Modeling Review of U.S. Steel Clairton Works Proposed C Battery Installation with Shutdown of Batteries 7-9

May 5, 2008

APPENDIX D

Modeling Review of U.S. Steel Clairton Works Proposed C Battery Installation with Shutdown of Batteries 7-9

Proposed C Battery Source Locations

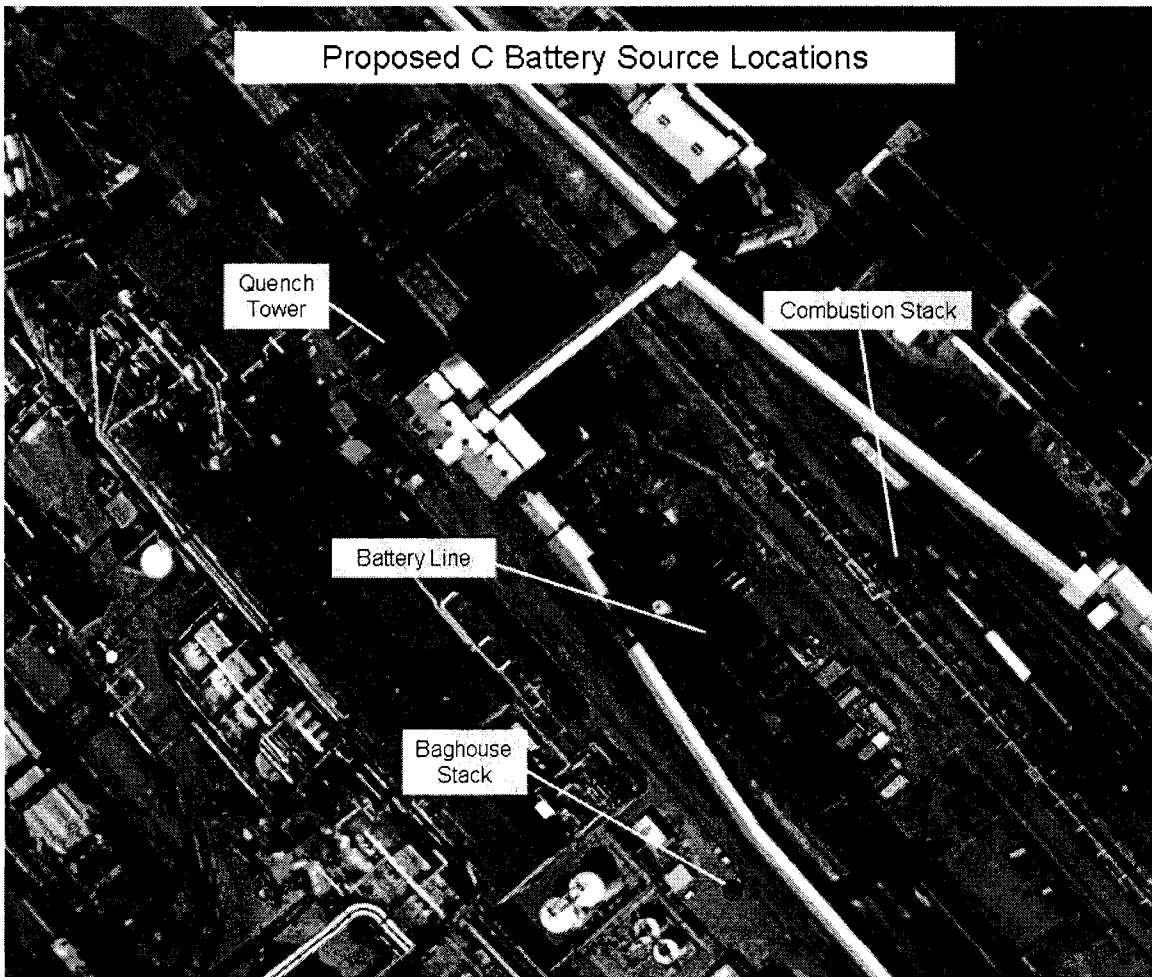
Below is an aerial map showing the key modeled locations of proposed C Battery sources.

C Battery is to be located to the southeast of B Battery, with similar dimensions to those of B Battery. Batteries 7-9 lie further to the southeast and would be simultaneously shutdown with the construction of C Battery.
